**Addendum No. 3**  
Page 1 of 23

**TO:** Prospective Respondents  
**SUBJECT:** Addendum No. 3  
**PROJECT NAME:** Romeoville Campus Expansion Bid Release 2  
**JJC PROJECT NO.:** B15028

This Addendum forms a part of the Bidding and Contract Documents and modifies the original bidding document as posted on the JJC website. Acknowledge receipt of this addendum in the space provided on the Bid Form. FAILURE TO DO SO MAY SUBJECT BIDDER TO DISQUALIFICATION.

ADDENDUM 3  
**A603.01**

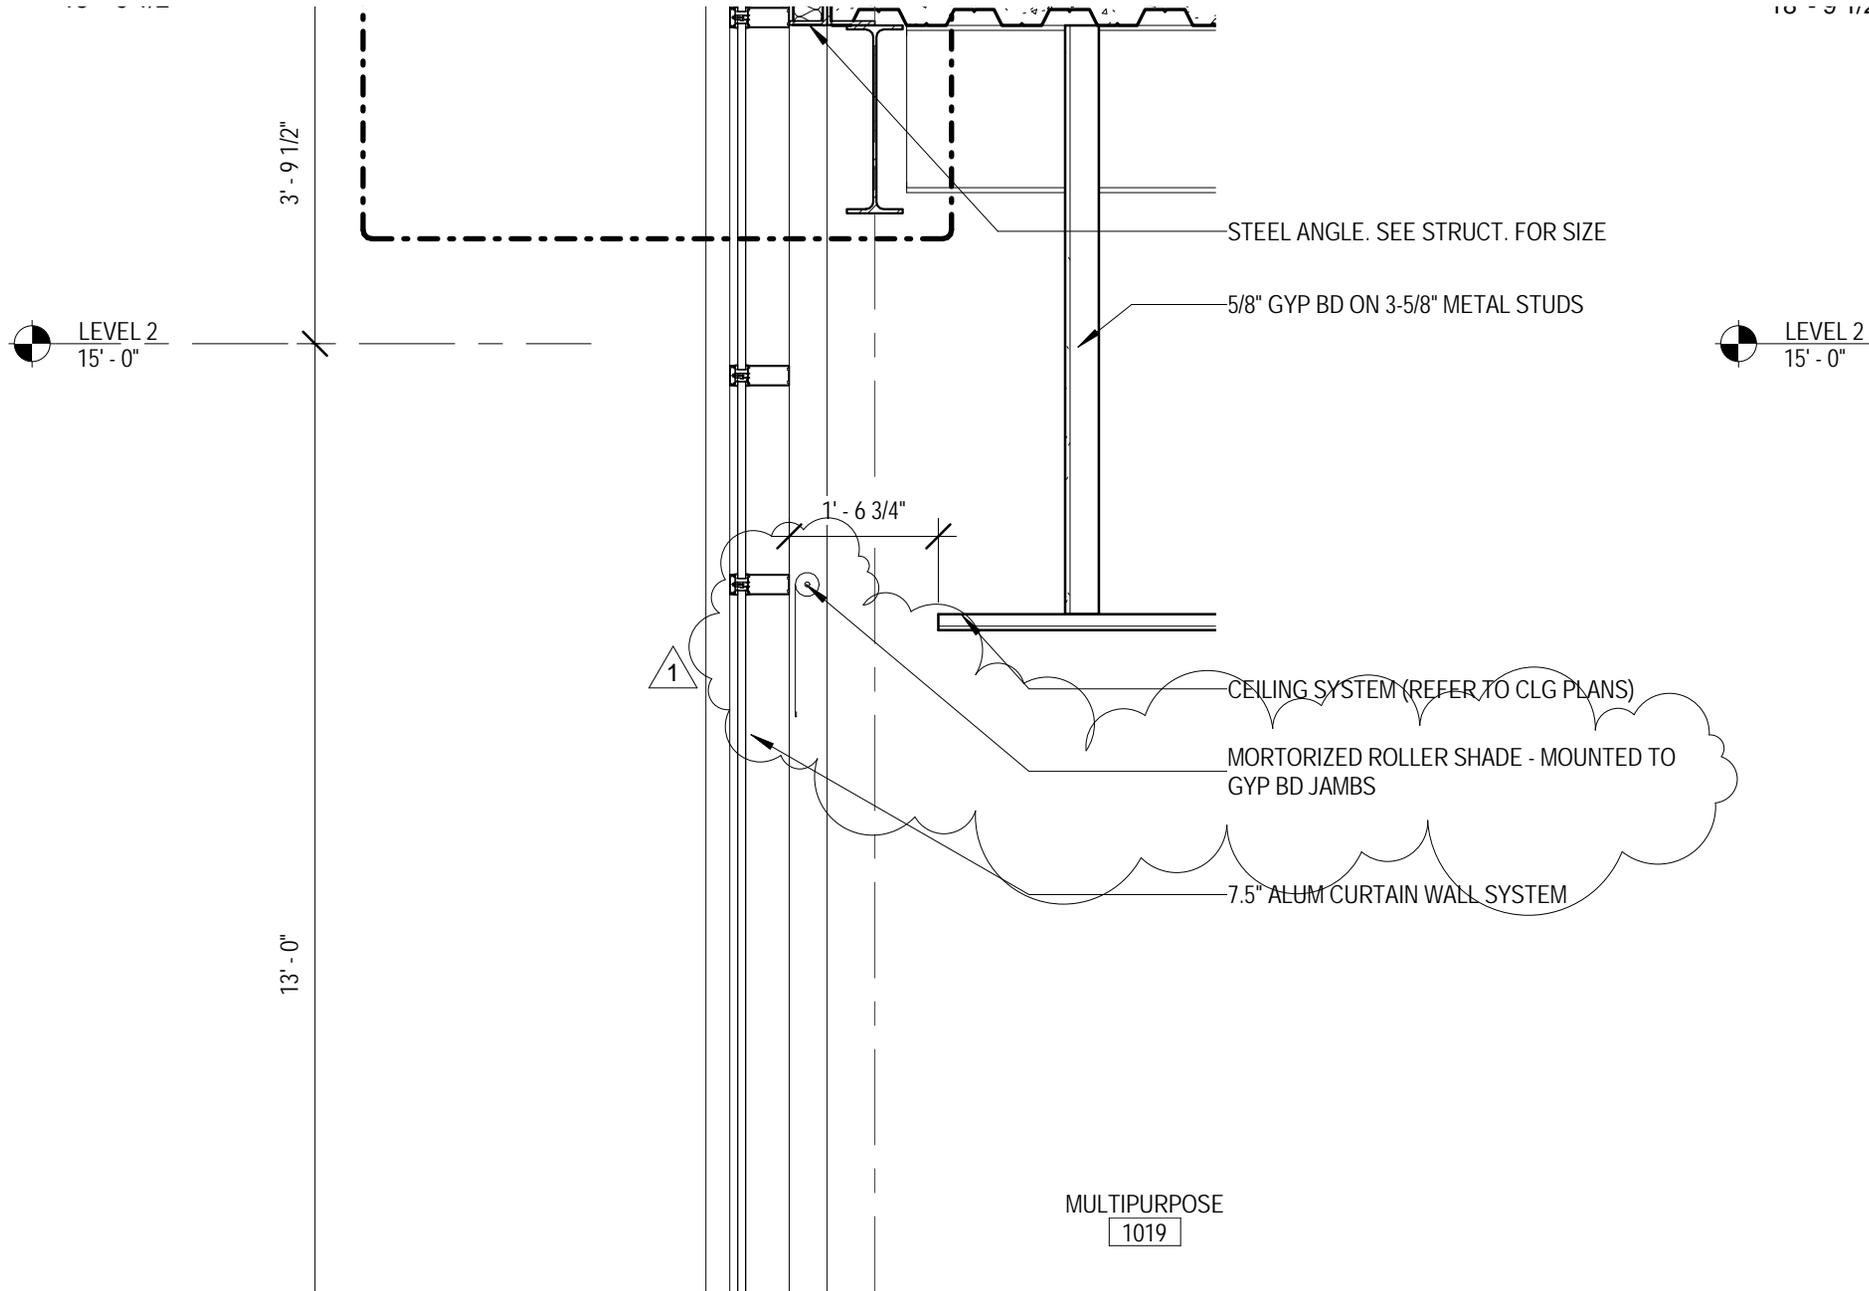
- G. Sheet A6.03: **REVISE** detail 4 per attached **sketch A603.01**.
- H. Sheet A6.04: **REVISE** detail 2 per attached **sketch A604.01**.
- I. Sheet A6.07: **REVISE** detail 3 per attached **sketch A607.01**.

**A701.01**

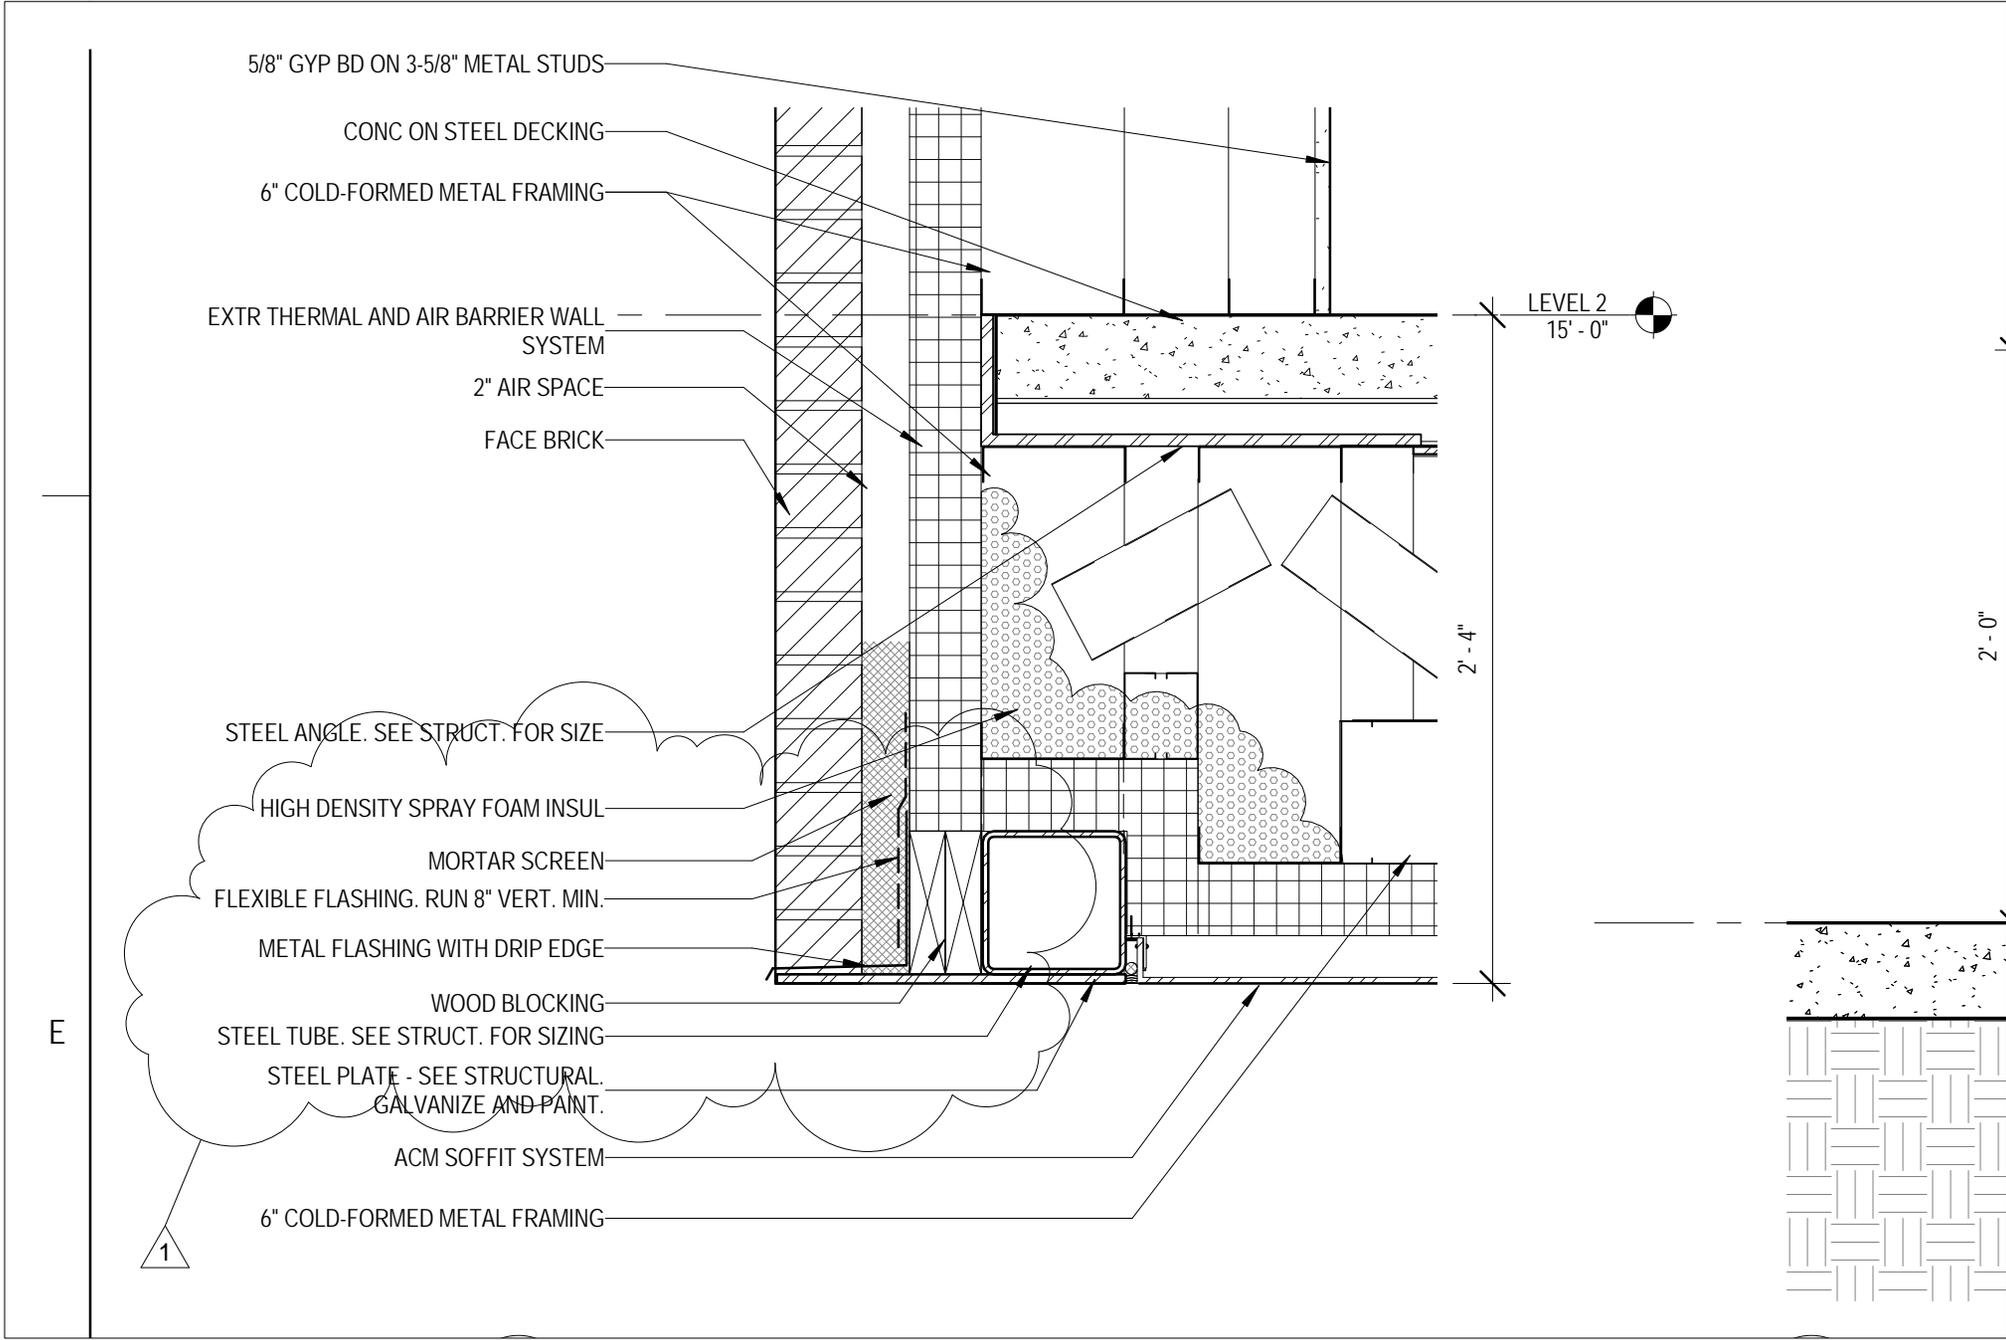
- J. Sheet A7.01: **REVISE** detail 8 per attached **sketch A701.01**.
- K. Sheet A7.02:
- 1) **REVISE** detail 8 per attached **sketch A702.01**.
  - 2) **REVISE** detail 7 per attached **sketch A702.02**.

A752.01

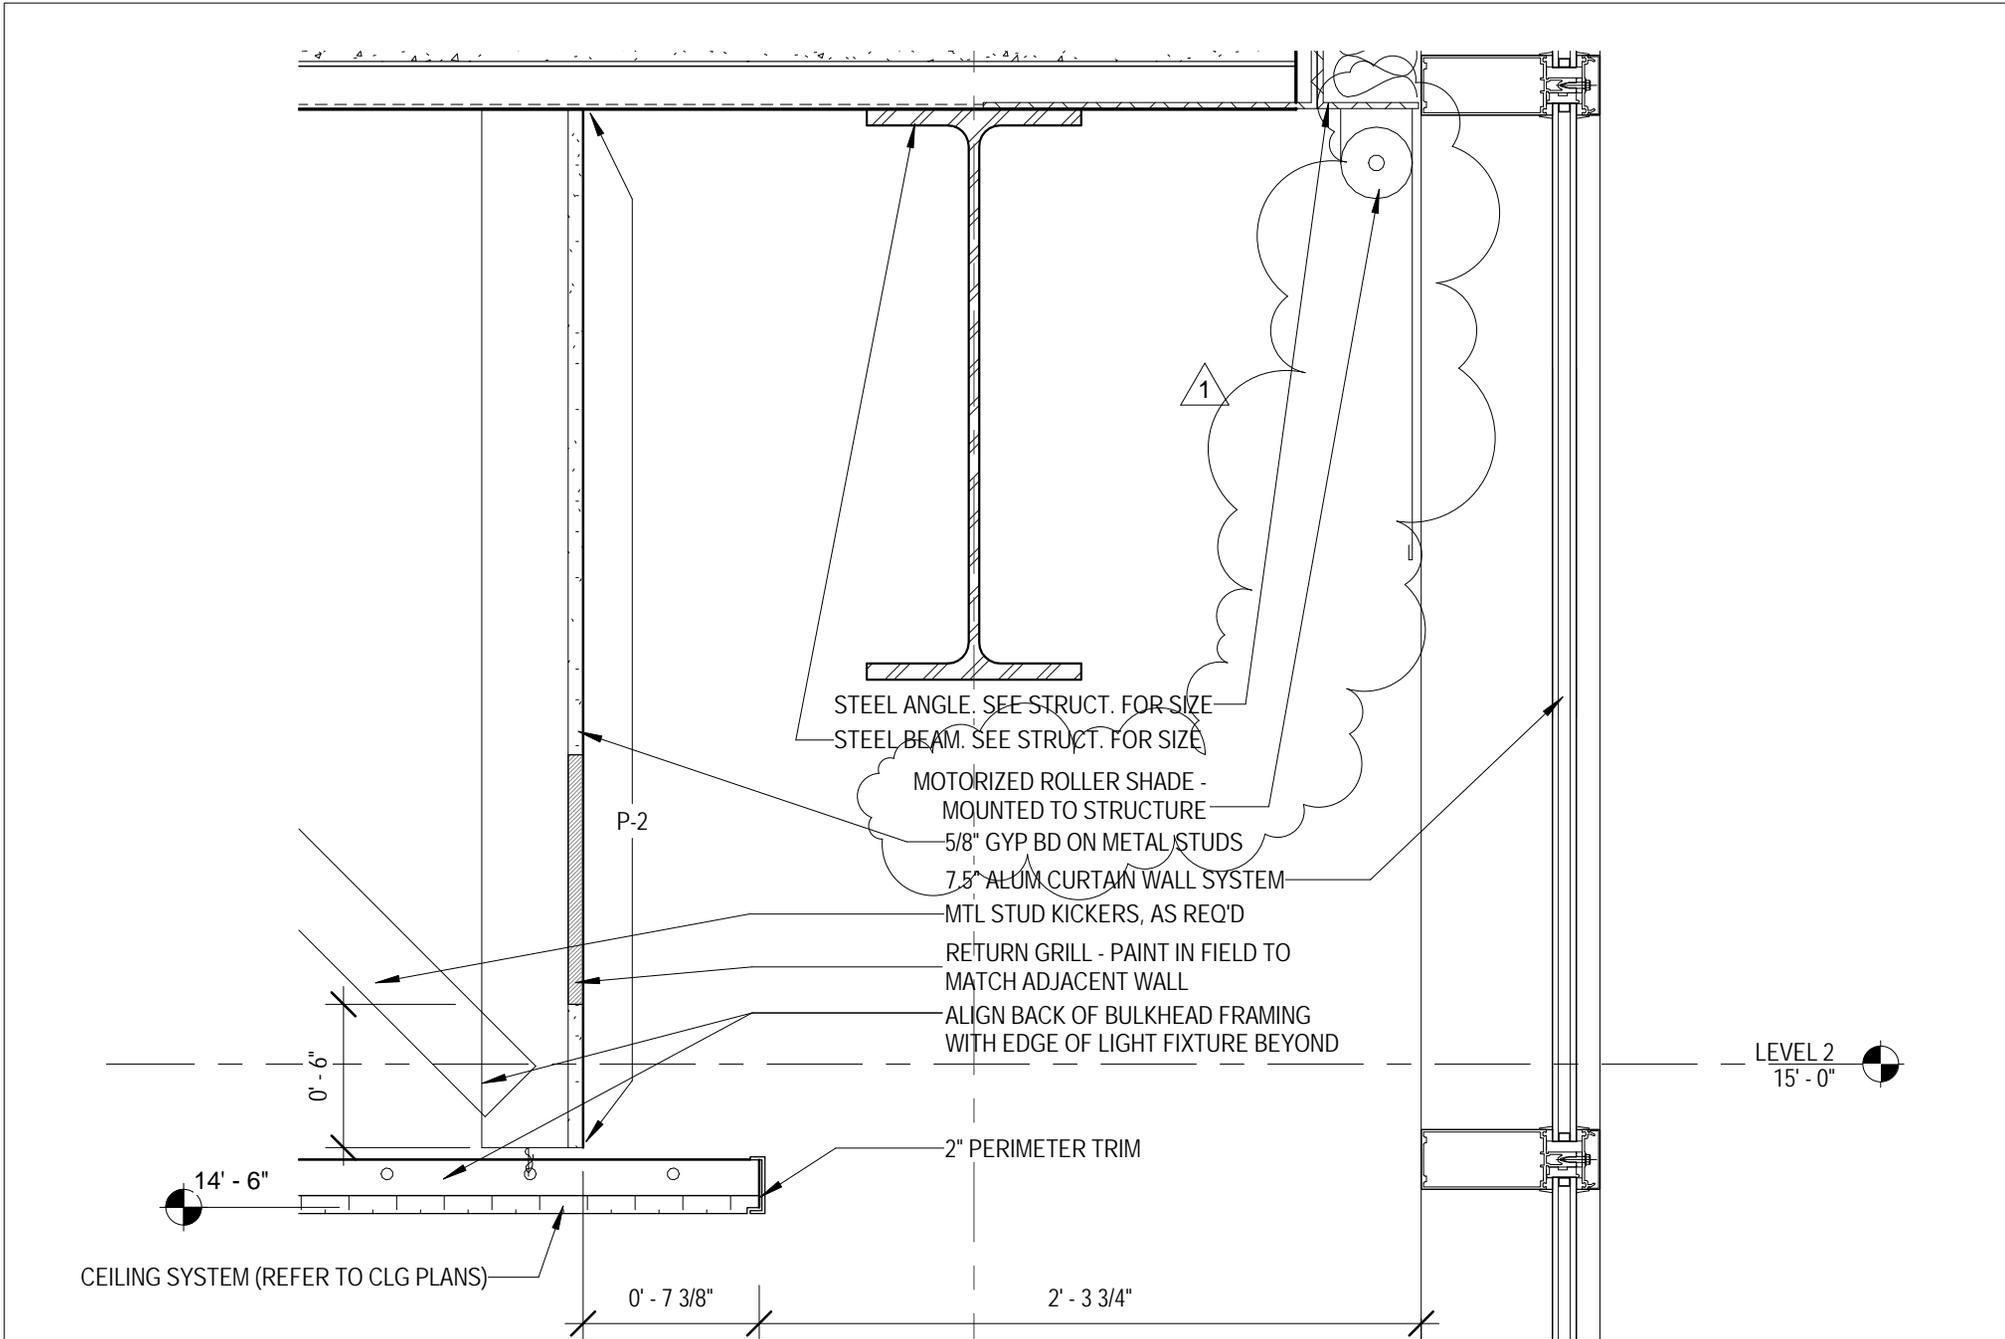
- L. Sheet A7.03: **REVISE** detail 9 per attached **sketch A703.01**.
- M. Sheet A7.51: **REVISE** detail 4 per attached **sketch A751.01**.
- N. Sheet A7.52: **REVISE** detail 3 per attached **sketch A752.01**.

A793.01

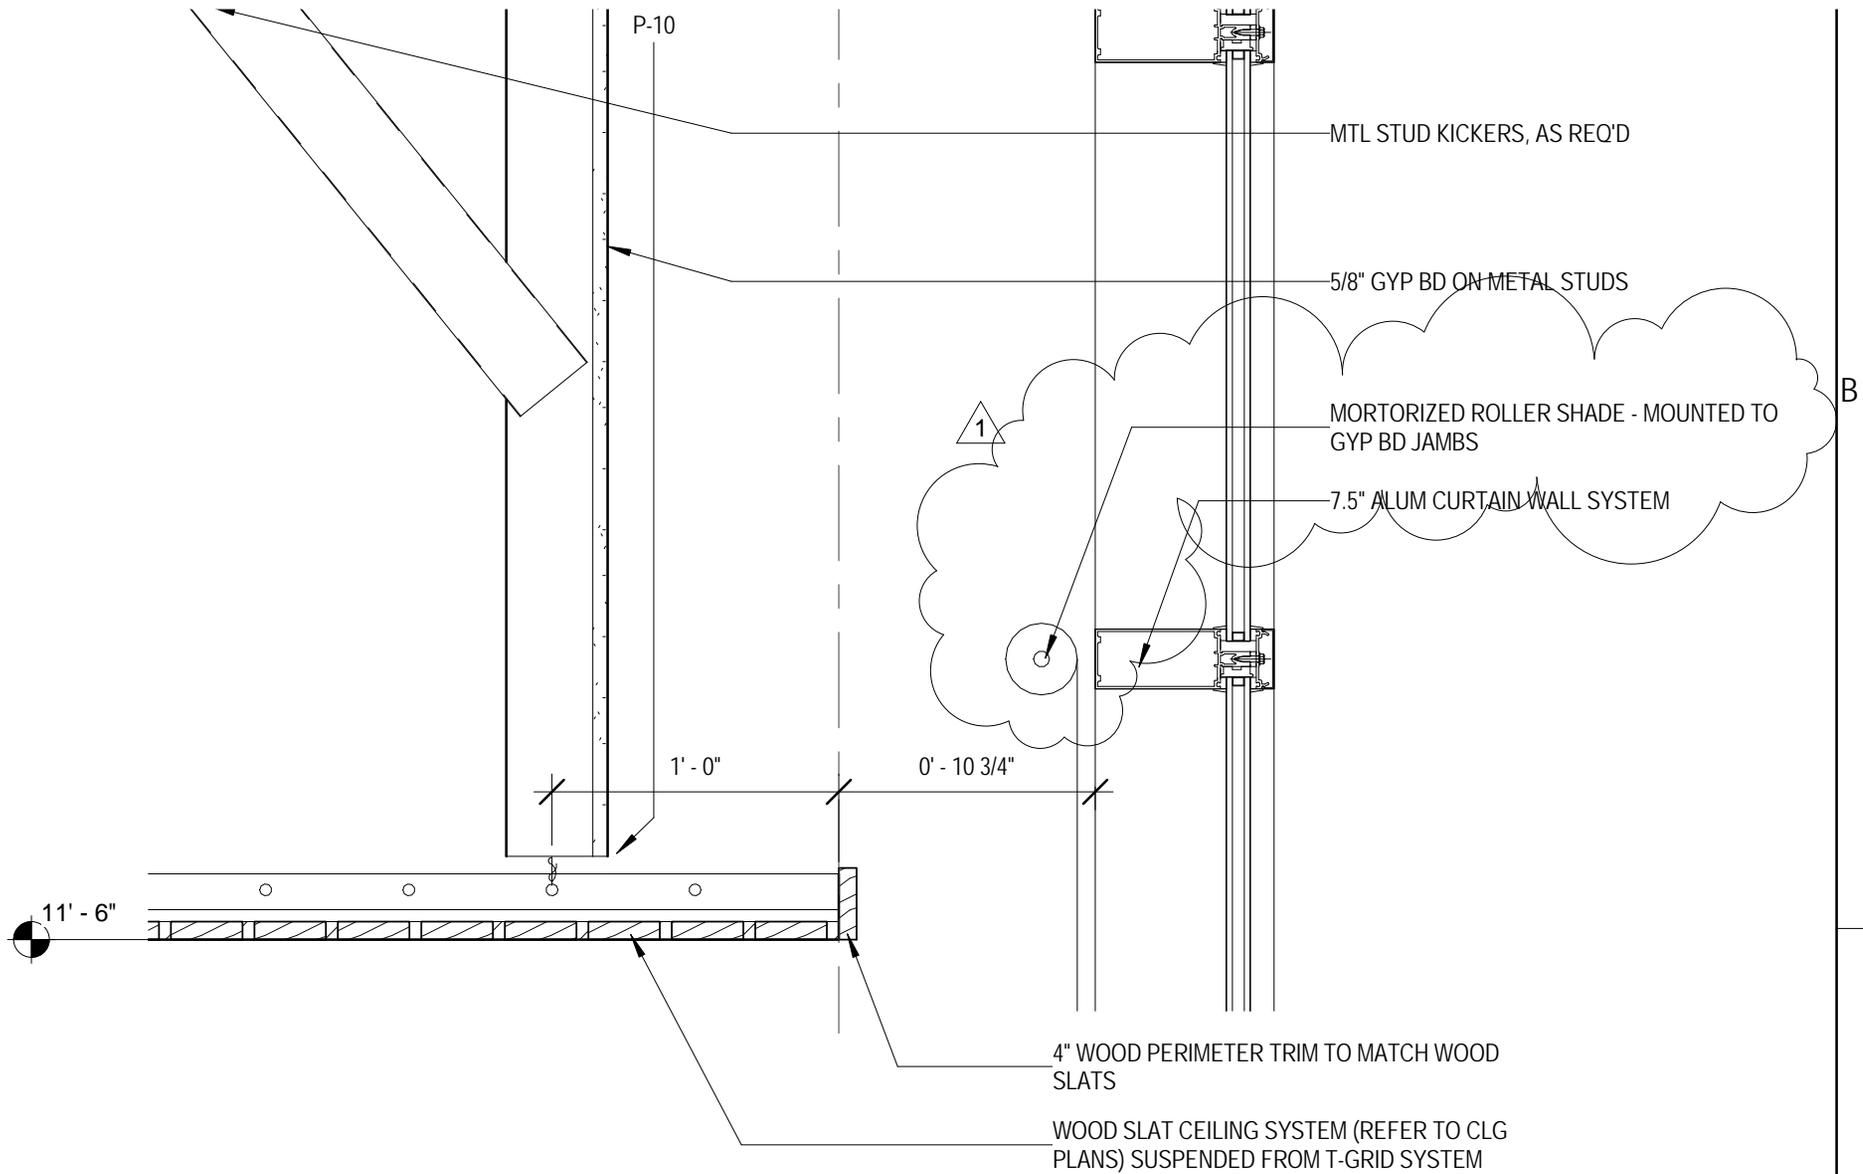
- O. Sheet A7.93:
- 1) **REVISE** detail 9 per attached **sketch A793.01**.
  - 2) **REVISE** detail 7 per attached **sketch A793.02**.
- P. All Science Labs Sheets – Lab Casework General Notes:
